Request from: Connecticut Siting Council

**PSEG Power Connecticut LLC
Petition No. 1218**

**Data Request CSC-08
Dated: 04/28/2016
CSC-08
Page 1 of 1**

Revised April 28, 2016

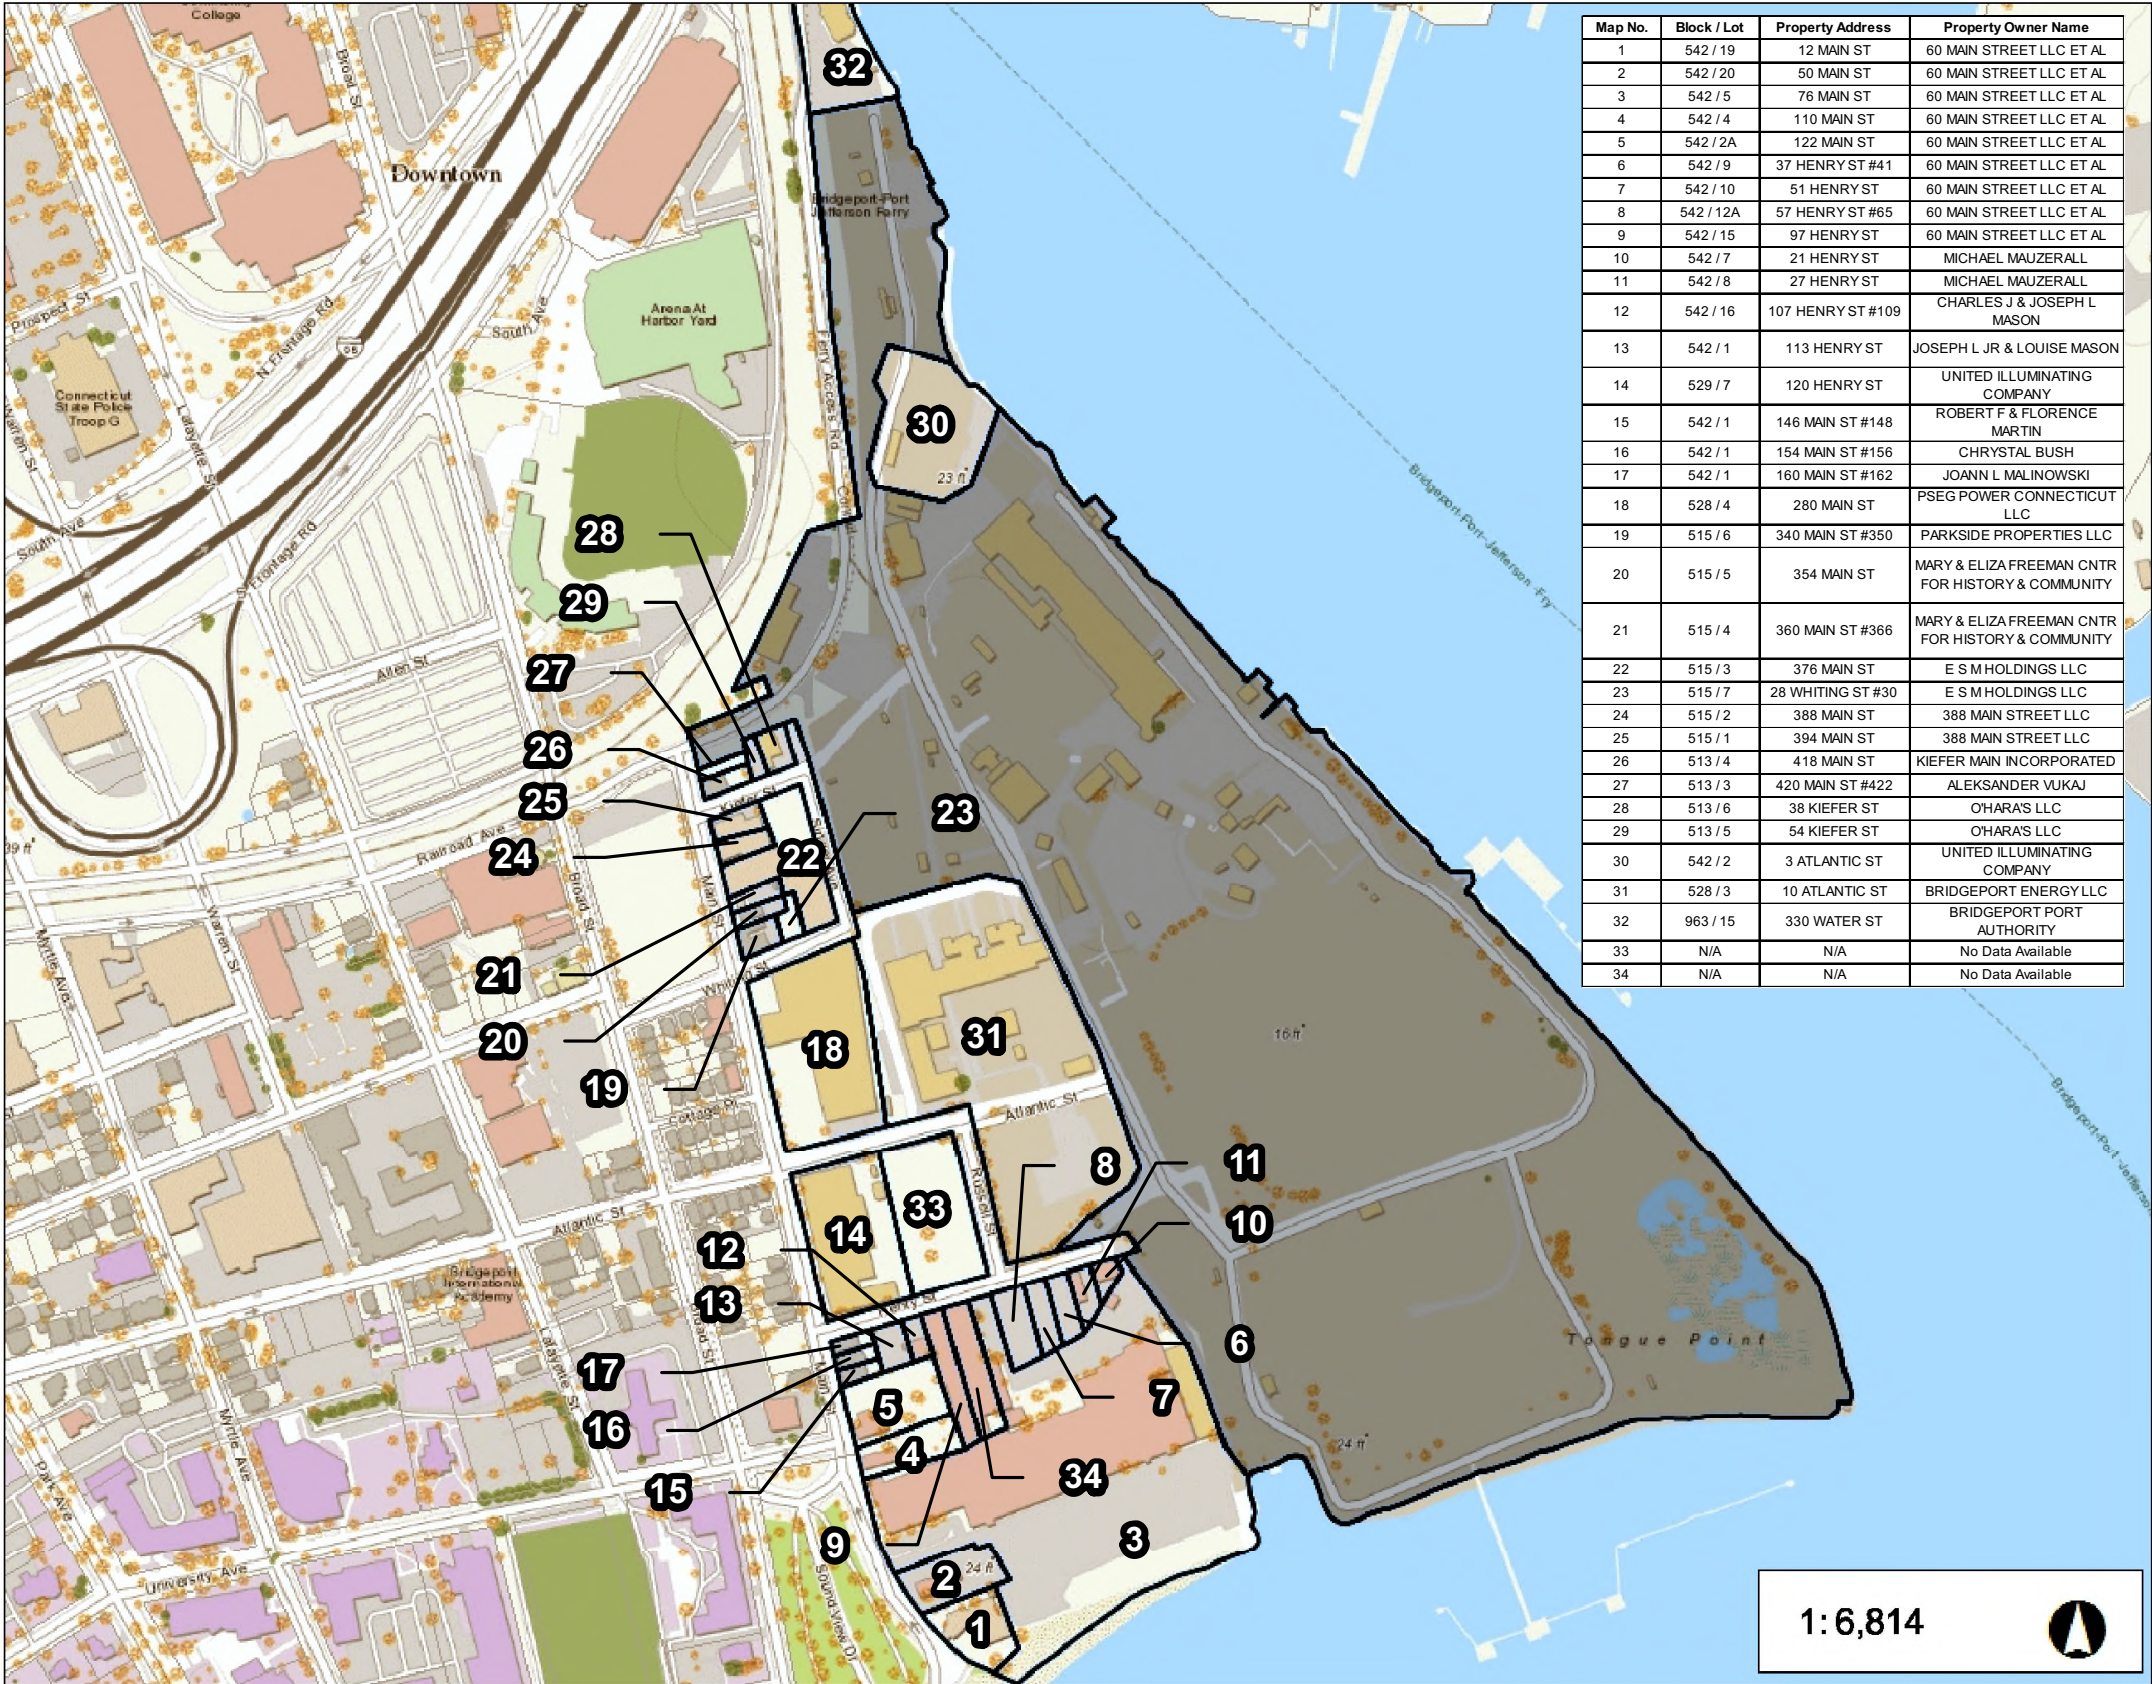
CSC-01. PSEG Power Connecticut LLC (PSEG or Petitioner) included Abutters Map L-1 under Tab L of the Petition (Petition) dated March 9, 2016. Please submit a properly labeled Abutters Map identifying each parcel owner, including but not limited to, the abutters listed under L-2 of Tab L of the Petition.

Response: Attached is a revised Abutters Map L-1 with each abutting parcel labeled and each associated property owner identified. The property owners identified on the attached map are consistent with the list provided as Exhibit L-2 of the Petition dated March 9, 2016.

BRIDGEPORT 05
PLANT LAYOUT
UNIT 5 COMBINED CYCLE PROJECT
SITE LAYOUT PLAN

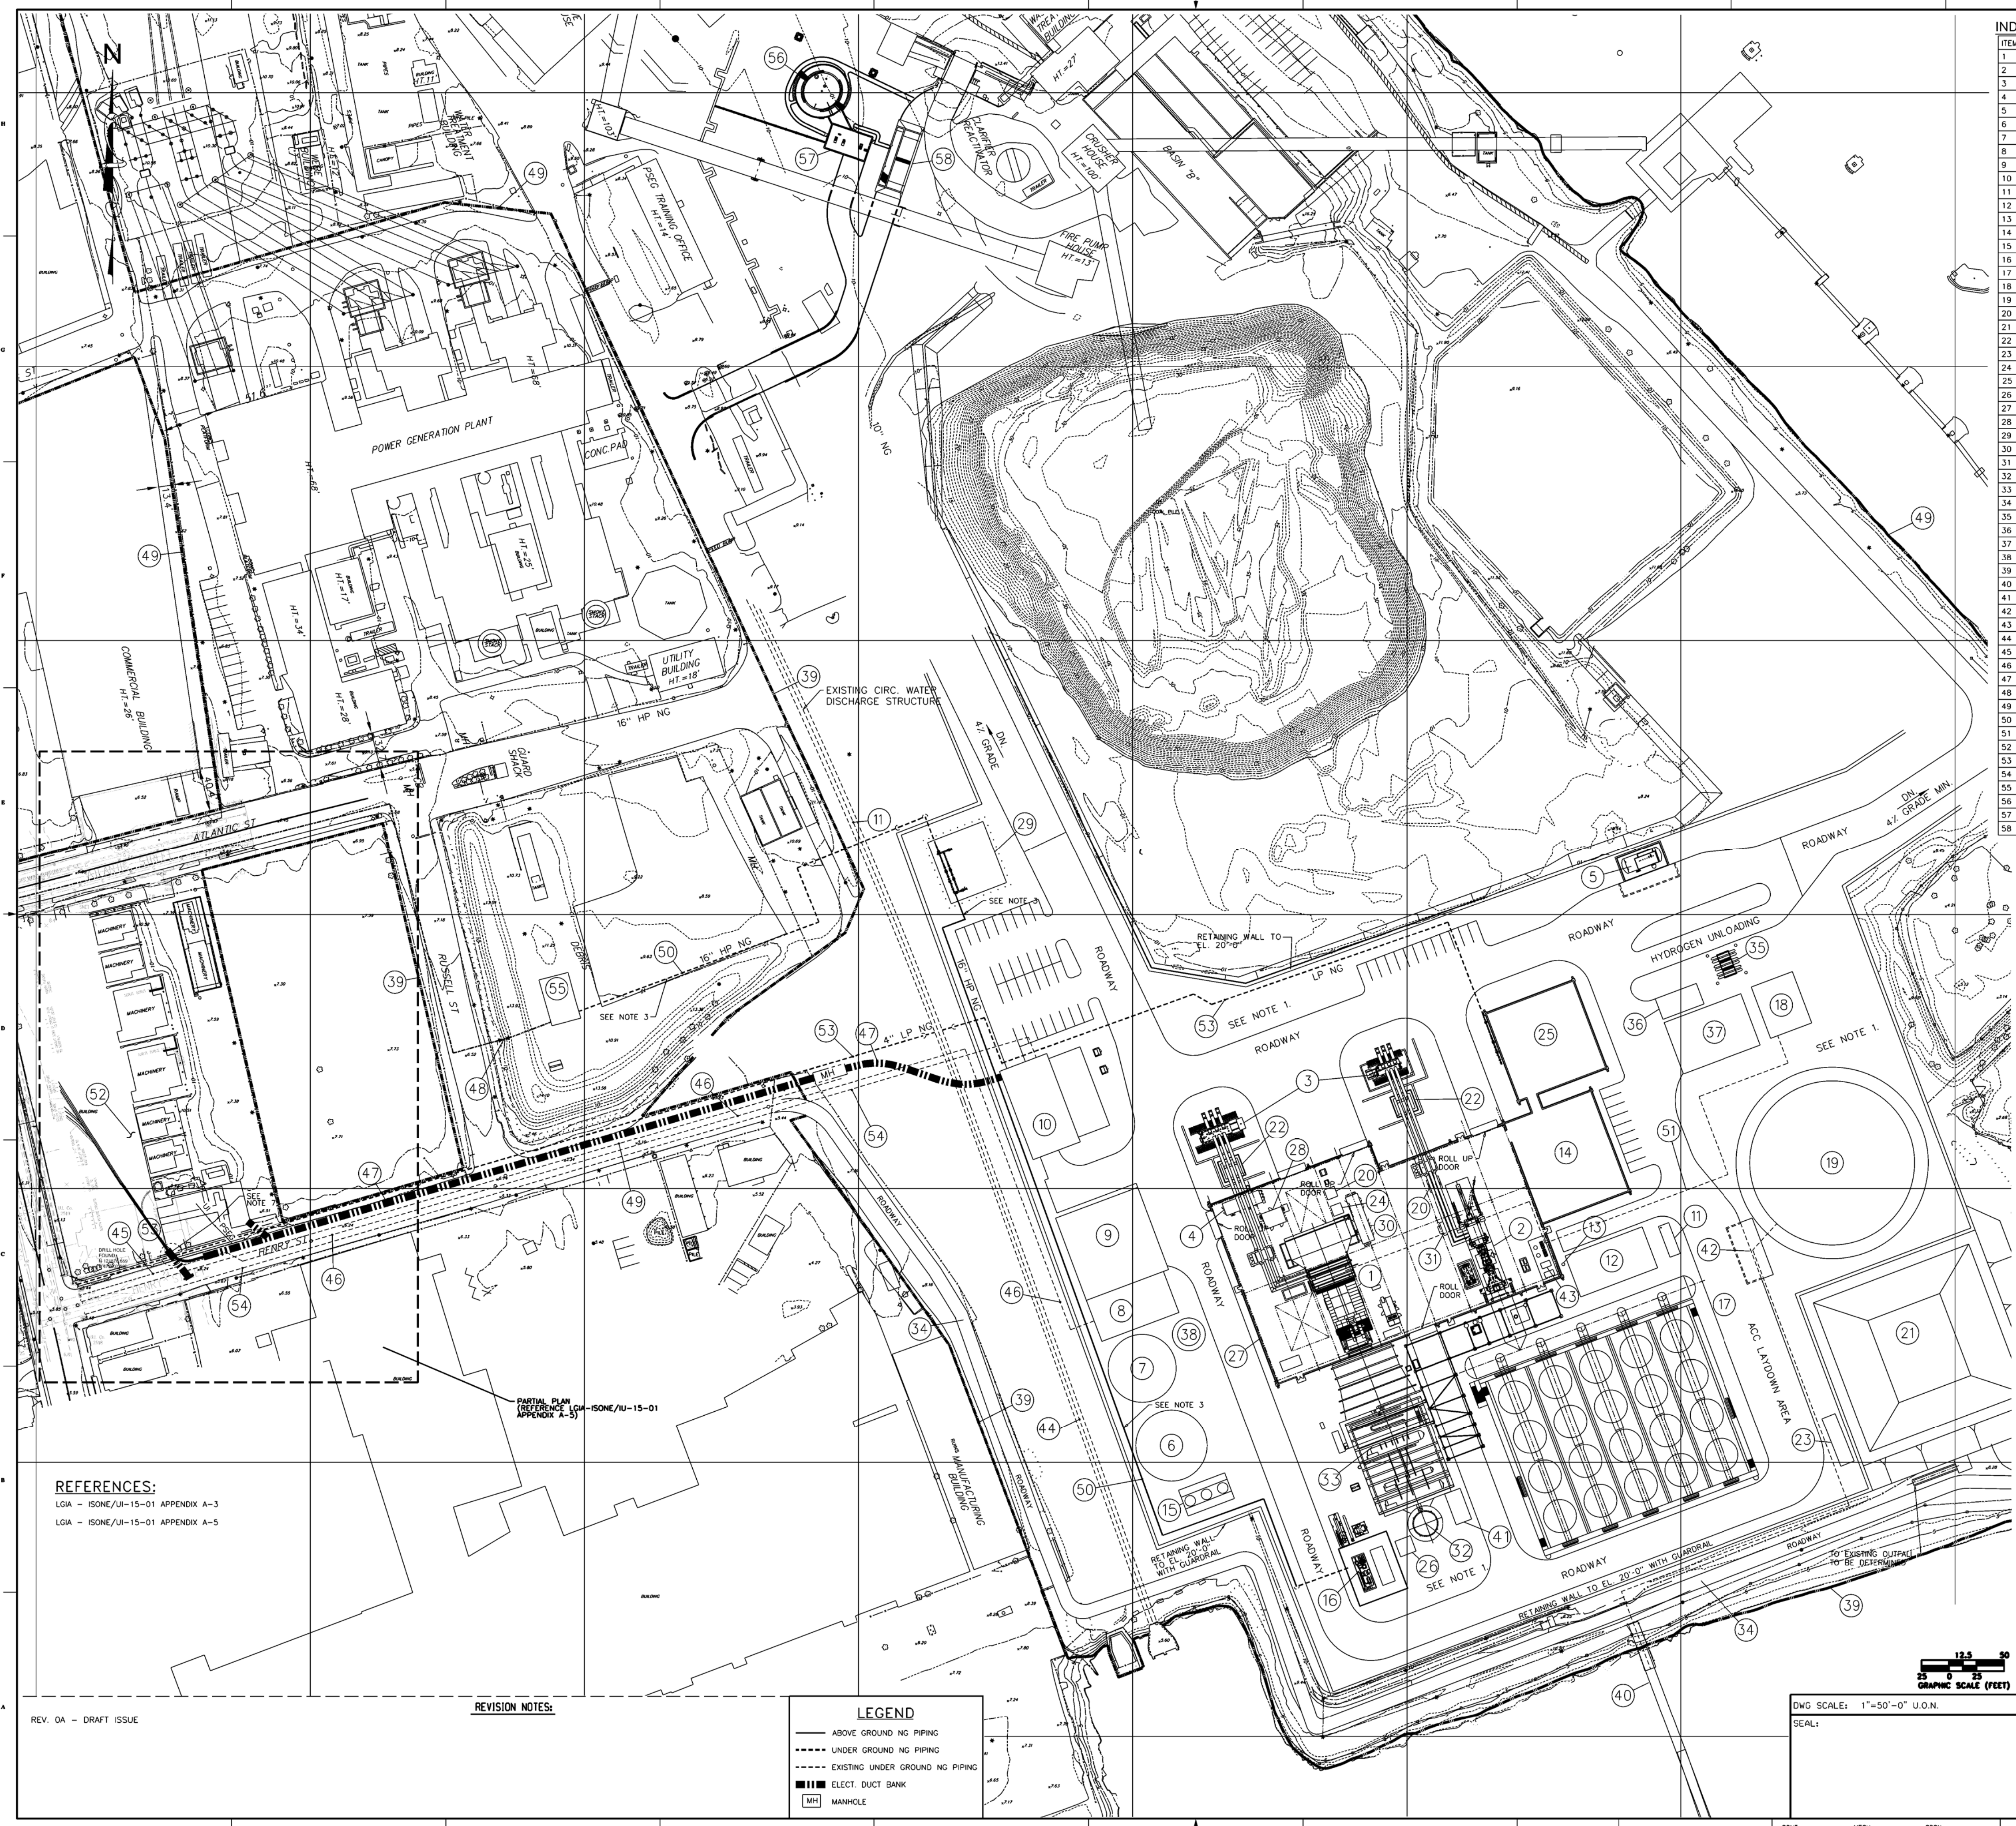
CSC-17. If the proposed project is approved, would PSEG (and/or The United Illuminating Company) file a separate petition for the 345kV underground electrical transmission cable and interconnection portion of the project or is this part of the instant Petition?

Response: The part of the interconnection that will be built, owned and operated by PSEG is part of Petition No. 1218. On January 19, 2016, PSEG (the “Interconnection Customer”), The United Illuminating Company (the “Interconnecting Transmission Owner”) and ISO New England, Inc. entered into a Large Generator Interconnection Agreement (“LGIA”). The LGIA specifies the Point of Interconnection, the Point of Change in Ownership and the construction responsibility of PSEG as summarized below:

Point of Interconnection and Point of Change in Ownership. The Point of Interconnection shall be at the Interconnecting Transmission Owner’s Singer 345 kV Substation in Bridgeport, Connecticut between switches 34C-42T-4 and 34C-41T-8. The Point of Change in Ownership between the Interconnection Customer’s 345 kV line and the Interconnecting Transmission Owner’s Singer Substation equipment will be at the conductor tap point on the cable that connects the Interconnection Customer’s 345 kV line to the Interconnecting Transmission Owner’s 345 kV terminal. The Attached Exhibit 17-A shows the plant layout.

Interconnection Customer’s Interconnection Facilities (including metering). The Interconnection Customer shall construct a 345 kV collector bus with gas insulated substation (“GIS”) equipment housed in a building. The output from the Large Generating Facility will be

directed by underground cable to the 345 kV GIS collector bus owned by the Interconnection Customer. Subsequently, a single radial, 345 kV 3000MCM XLPE underground transmission cable will be constructed, owned and operated by the Interconnection Customer. This underground transmission cable will run from the Large Generating Facility to and in Henry Street, a public street in Bridgeport, Connecticut, to the Interconnecting Transmission Owner's Singer 345 kV substation. The Interconnecting Transmission Owner has consented to the Interconnection Customer constructing, owning and operating the single radial, 345 kV 3000MCM XLPE underground transmission cable circuit in Henry Street. The Interconnection Customer's underground transmission cable will enter the Interconnecting Transmission Owner's facility and terminate at the GIS with a high voltage cable termination. The transmission cable connection can be isolated and grounded from both ends when needed. The Interconnection Customer's 345 kV substation will use a radial arrangement with the main bus rated for 2000A, and will consist of three circuit breaker bays. Each breaker bay will have a manual disconnect switch for a visible safety isolation break from the substation main bus. A three-phase GSU is required for each of the two generators comprising the Large Generating Facility to convert from the generators' output voltage to the grid 345 kV level. The transformers are sized to carry the full capacity rating of the Large Generating Facility. A circuit breaker and disconnect switch are provided for each turbine/generator to isolate each one from its respective GSU. Isolated-Phase buses rated at 25kV and 18kV are provided to connect the unit outputs to their respective GSUs. The attached Exhibit 17-B shows the specifics of the layout and interconnection.
